Date of Issue: December 2022 (*Monogram Program Effective Date: June 2023*)

Affected Publication: API Specification 17D, *Specification for Subsea Wellhead and Tree Equipment*, 3rd Edition, October 2021

Addendum 1

Figure 4: The figure shall be changed to the following:

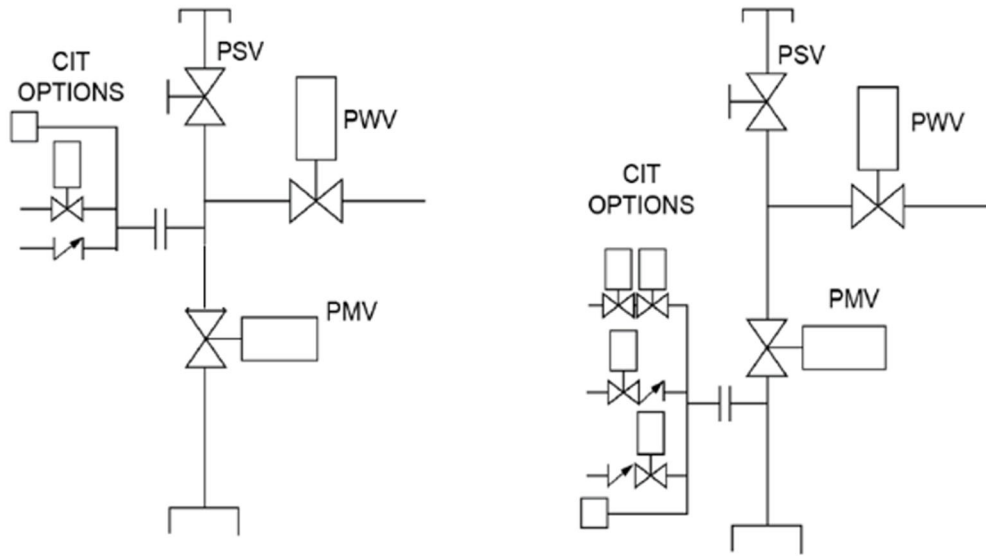
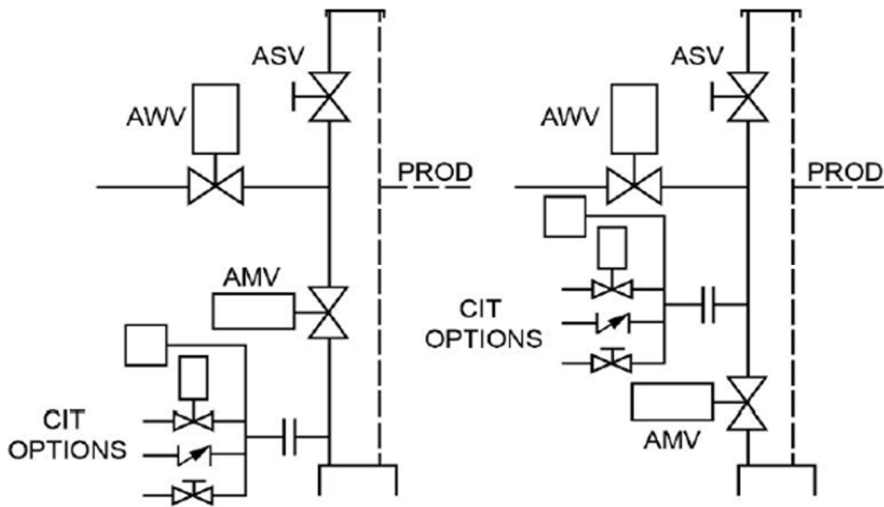
a) Production Bore Penetrations

b) Annulus Bore Penetrations

6.2.9: The NOTE at the end of the section shall be changed to the following:

NOTE Figure 4 illustrates typical configurations that meet the requirements of this section.

Table 8 —API-type SBX Pressure-energized Ring Gaskets

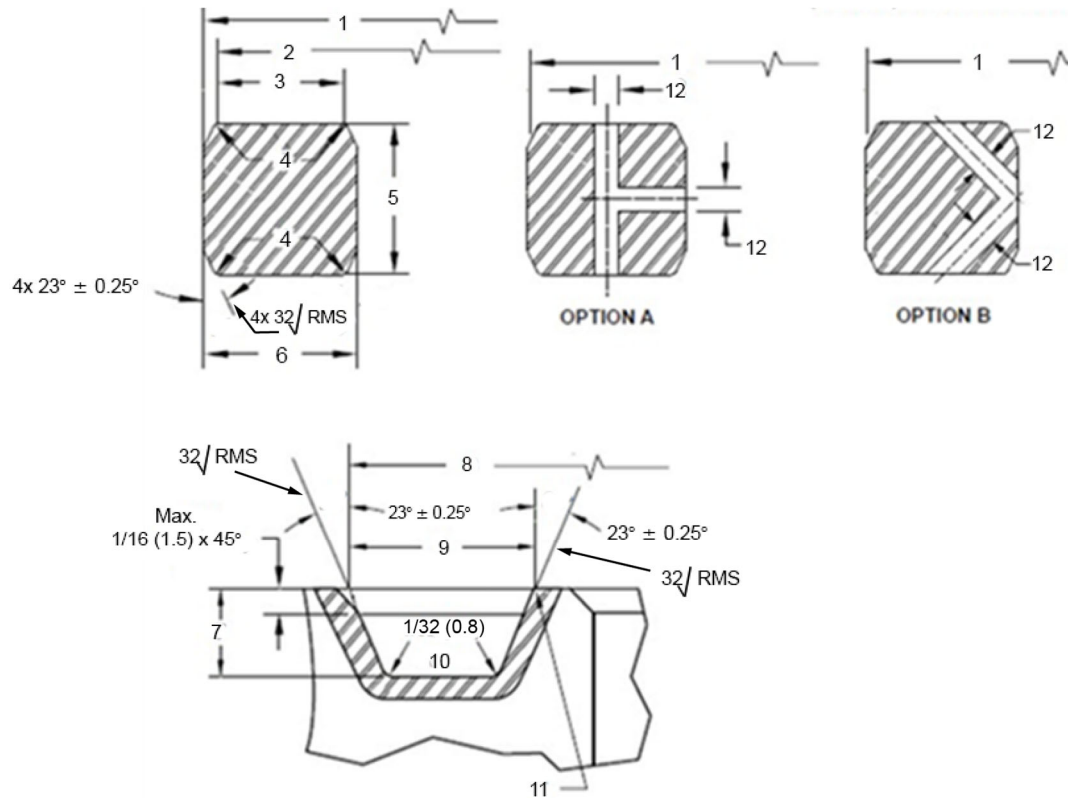
Table 8: The table shall be changed to the following:

NOTE 1 Radius R shall be 8 % to 12 % of the gasket height, H .

NOTE 2 Two pressure passage holes in the SBX ring cross section prevent pressure lock when connections are made up underwater. Two options are provided for drilling the pressure passage holes.

Figure E.4: The figure shall be changed as indicated in the red boxes:

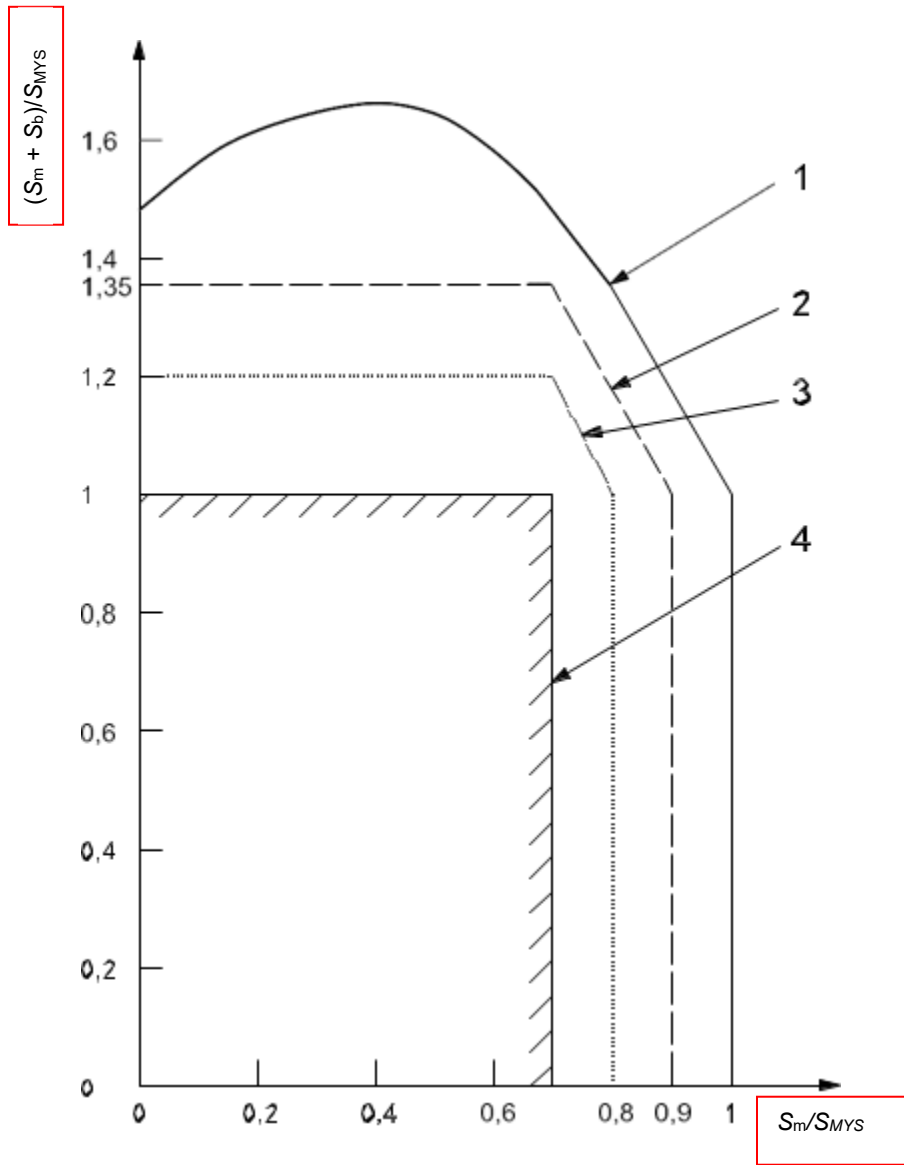
NOTE 2 Assuming the simple case of a rectangular beam and an elastic/perfectly plastic material, a plot of limiting membrane-plus-bending versus membrane-only stress can be made (see ASME BPVC Section II and ASME BPVC Section VIII). Figure E.4 shows the limiting values of various combinations of membrane-plus-bending and membrane-only stresses normalized using the minimum specified material yield strength, S_{MYS} , which is the allowable limit on local primary membrane and local primary membrane-plus-bending stress. The limit stress ratio for membrane only is 1.0, and for bending only, the limit is 1.5. If a membrane stress less than $2/3 S_{MYS}$ is added to a large bending stress, the membrane-plus-bending stress ratio may exceed 1.5. This is due to the stiffening effect of the membrane stress and shifting of the beam's neutral axis. This increase in bending capacity when axial load is applied is generally ignored.
